**Subject:** Addendum Geotechnical Report per County of Riverside  
**Project Address:** N.W.C Central Ave (74 Hwy) & Allan St, Lake Elsinore California

**RE: Review Comments**  
**County Geologic Report No. 210009**  
**“Preliminary Geotechnical Investigation Report for Foundation Design, Proposed Commercial Retail, NWC Central Ave (74 Hwy) & Allan St, Lake Elsinore, California,” dated July 20, 2020.**

PORTION OF USGS OPEN FILE RPT. 03-281

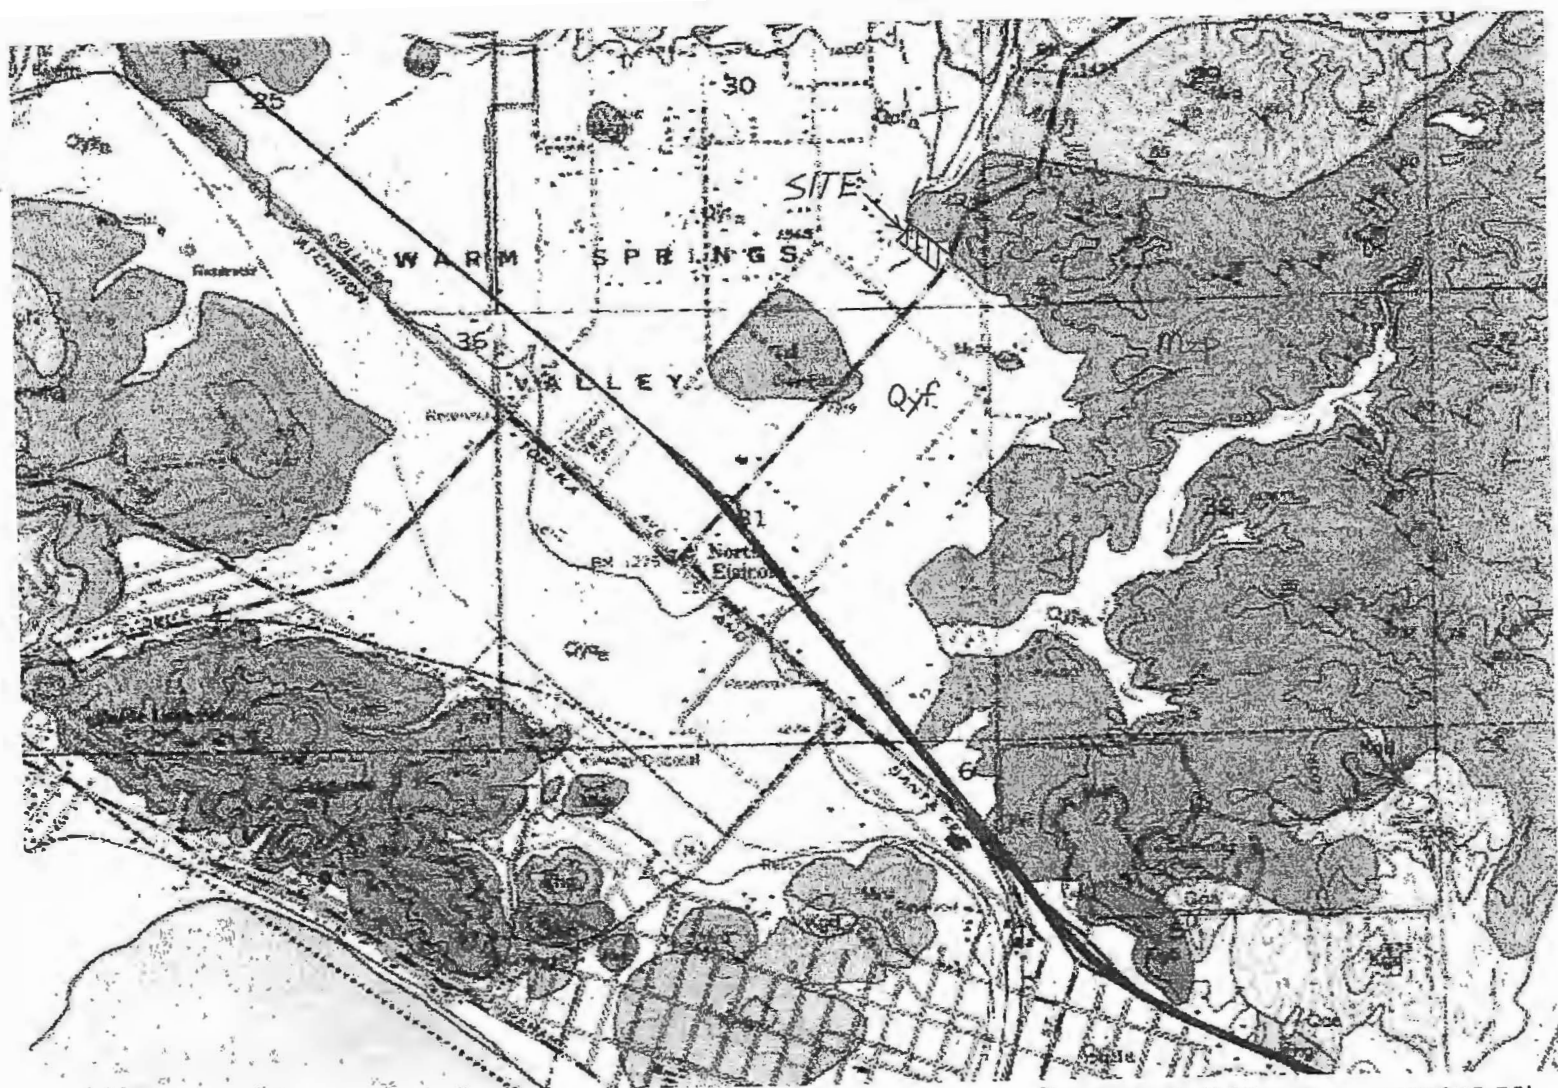
4. Please provide a geologic map with north arrow, a minimum scale of (1in:2,000 ft.), legend, and reference indication.
5. Provide an estimate of the total and differential seismic settlement potential for the site.

A Regional Geologic Map is attached to this response report.
